RESOLUTION SETTING HEARING ON APPEAL OF BRADLEY & BELINDA MC ANINCH (OWNER), REPRESENTED BY BRADLEY MC ANINCH (OFFICER), ON A DENIAL OF TYPE 2 DESIGN ALTERNATIVES FOR A PUBLIC HEARING SITE PLAN FOR PROPERTY LOCATED AT 4700 SOUTHEAST 14TH STREET

Communication from the City Plan and Zoning Commission advising that at their November 16, 2023 meeting, the following action was taken regarding a request from Bradley & Belinda Mc Aninch (owner), represented by Bradley Mc Aninch (officer), for review and approval of a Public Hearing Site Plan "Brad's Collision," for property located at 4700 Southeast 14th Street, and for the following Type 2 Design Alternatives in accordance with City Code Sections 135-9.2.4(B) and 135-9.3.1(B):

BRAD'S COLLISION REBUILD
4700 SE 14TH ST., DES MOINES

Brad's Collision Center - New Facility

LAYOUT PLAN

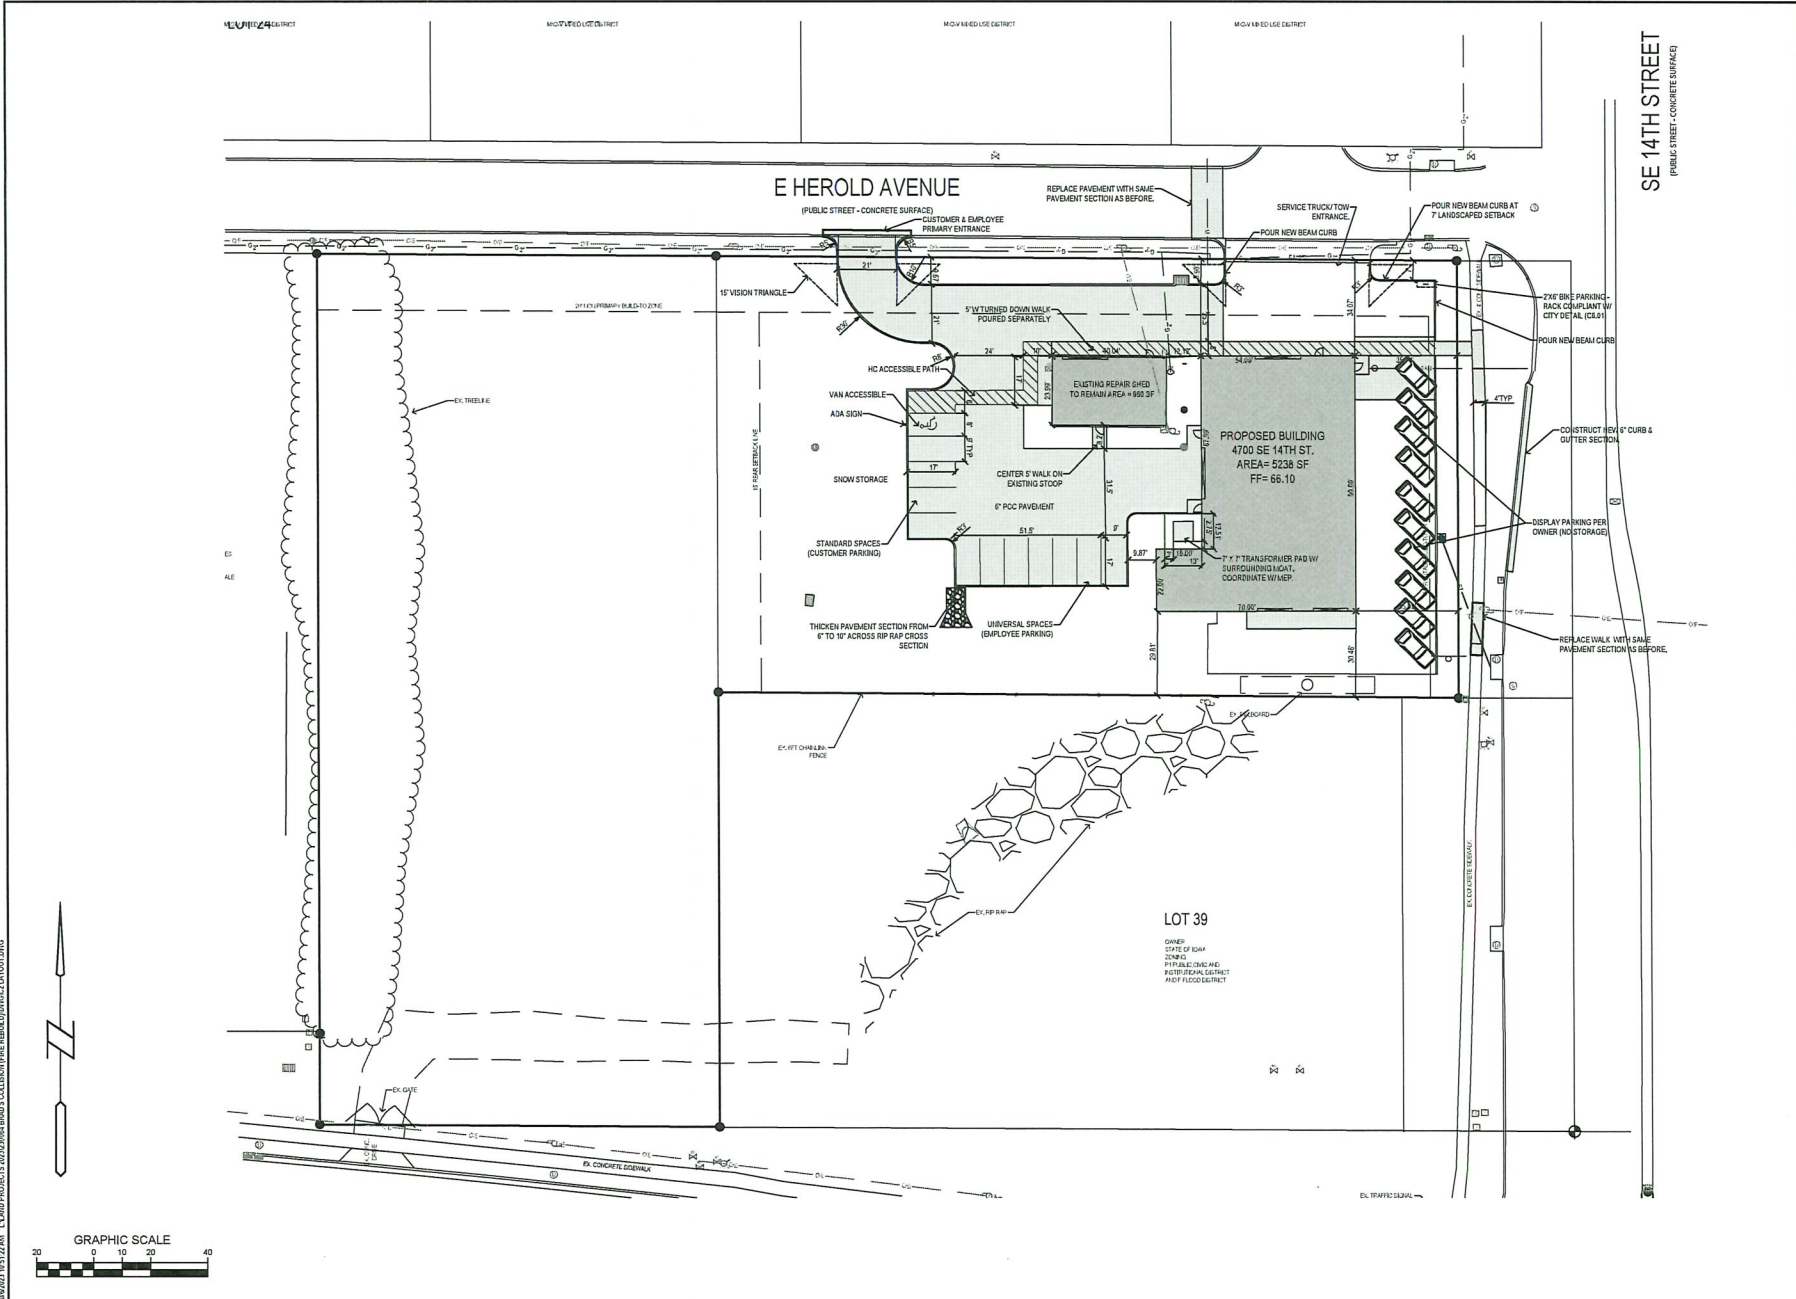
1. **Sidewalk:** East Herold Avenue is a priority one sidewalk gap within the city's transportation plan, MoveDSM. Sidewalk currently exists west of the applicant's property along several residential properties. Staff expects a site plan to be submitted for the property directly west of the Brad's Collision site at 1212 East McKinley Avenue. The property owners at 1212 East McKinley Avenue have been instructed that sidewalk installation along East Herold Avenue would be required. The applicant owns both properties adjacent to 1212 East McKinley and would be able to provide the missing sidewalk connection to Southeast 14th Street. A portion of the sidewalk may need to be located on private property to avoid the existing utility poles. A public access easement would be needed in this case. Staff believes this sidewalk installation is integral to providing connectivity and walkability for the western residential properties to access Southeast 14th Street. Staff does not support the waiver of priority one sidewalk installation.

Will Page asked if the sidewalk is included on the proposed site plan.

Michael Delp stated there is sidewalk along the eastern side of the building but not along the north. The north side is along East Herold Avenue, which is designated as a priority 1 sidewalk route.

Jason Van Essen acknowledged that the location of utility poles impacts where the sidewalk would need to be constructed. The solution is to construct the sidewalk so that it is partially on private property. A public access easement would be required for the portion of the walk that extends onto private property. This is a technique that is commonly used.

A5.1

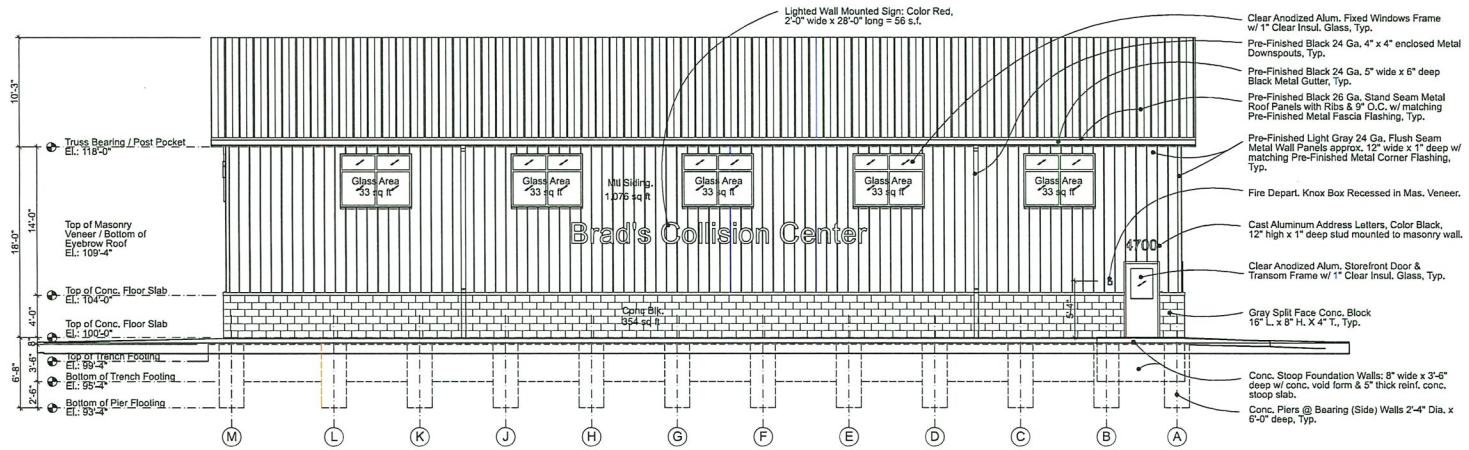
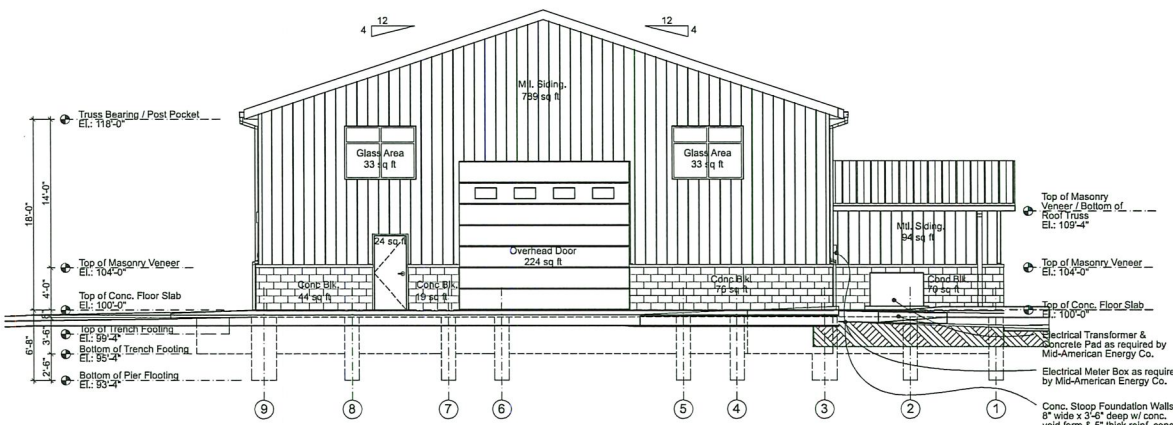
2. **Building Design and Form:** The Storefront building type is a low-to-midrise building type used along commercial corridors to promote interaction with the public realm, and to activate public interaction by providing transparency and entrances on the primary street facing façade. The proposed project is allowed to rebuild within the same footprint as the previous building without conforming to the required setbacks due to the destruction of the previous building. Other than the footprint, the proposed building must conform with the required transparency, building design requirements, and the general form of the Storefront building type.

The proposed building design resembles a typical structure found in an industrial context. A Storefront building would typically include a parapet roof, a mix of major façade materials, a street facing primary entrance, and significant transparency between 2 and 8 feet on a street facing façade. The exterior of the applicant's proposed building would include 24-gauge metal siding and 26-gauge pitched metal roofing with split face concrete blocks around the base of the building on all sides. There is no transparency proposed within the required 2 and 8 feet along the primary

façade. The proposed design would not meet the intended commercial character for the corridor.

Jason Van Essen noted that with the overhead door and lack of transparency, a lot of the same issues would still apply.

Rick Trower questioned the appropriateness of the proposed design for the corridor. Indicated the proposed roof is the least expensive option for a roof. Indicated he had reservations about the project not complying with the transparency requirements and thought the applicant should work with staff on a solution.

Chris Pose, 505 5th Avenue Suite 1005 stated the reason for lack of transparency along the primary façade is due to the robbery and arson that occurred last January. They are providing windows at a higher level to meet the intent of city code but also trying to prevent future theft. This effort would be continued along the north side of the building and would also allow the owner to use the indoor space for bodywork. The owner is trying to provide a more attractive building than the previous one, which has triggered the waivers before the Commission.
